Work Order ID 87143

Item ID: D3393-1 Accept ***N900040100*** Setup Start ***NS1***
 Revision ID: Stop ***NS2***
 Item Name: Battery Lock Casing
 Start Date: 7/10/12 Start Qty: 5.00 ***5*** Cust Item ID:
 Required Date: 8/17/12 Req'd Qty: 5.00 ***5*** Customer:
 Reference:

DART AEROSPACE LTD		Work Order:	87143
Description: Battery Lock Casing		Part Number:	D3393-1
Inspection Dwg: D3393 Rev: A		Page 1 of 1

DESIGN 13	DRAWN BY 13	DART AEROSPACE LTD HAWKESBURY, ONTARIO, CANADA	
CHECKED 77	APPROVED <i>[Signature]</i>	DRAWING NO. D3393	REV. A
DATE 05.02.09	TITLE BATTERY LOCK	SHEET 2 OF 3 SCALE 1:1

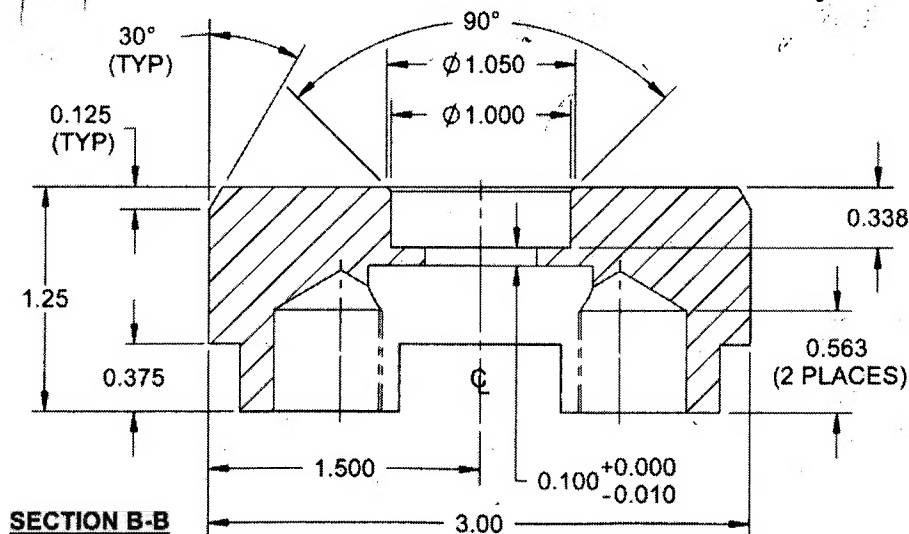
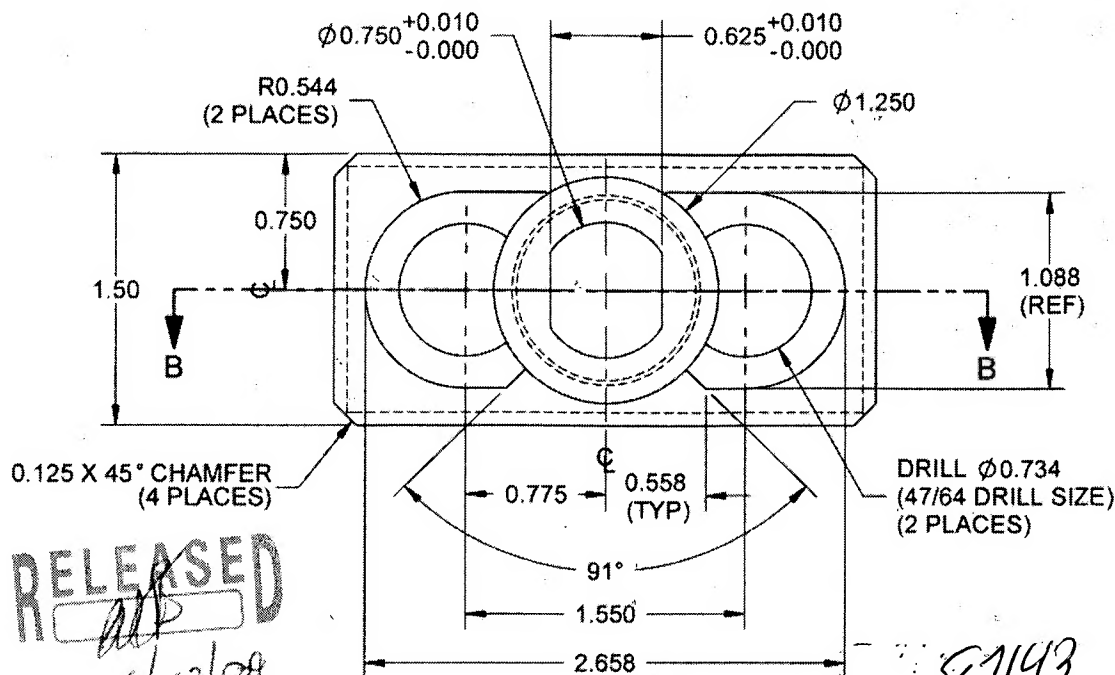
NCR: 12-1704		WORK ORDER NON-CONFORMANCE (NCR)						
DATE	STEP	Description of NC Section A	Corrective Action Section B			Verification Section C	Approval Chief Eng	Approval QC Inspector
			Initial Chief Eng	Action Description Chief Eng	Sign & Date			
12/08/13	110	one of the .734 holes is .748" and is slightly on an angle because the center drill broke into part and the drill deviated.		Acceptable	B.A. 12/08/13	SL 12-08-14		
		RC. Process / PROGRAM → Feed has been changed in program for the center drill → Tried the part on the						
		battery and the fit is good and there is still enough clearance on each sides.
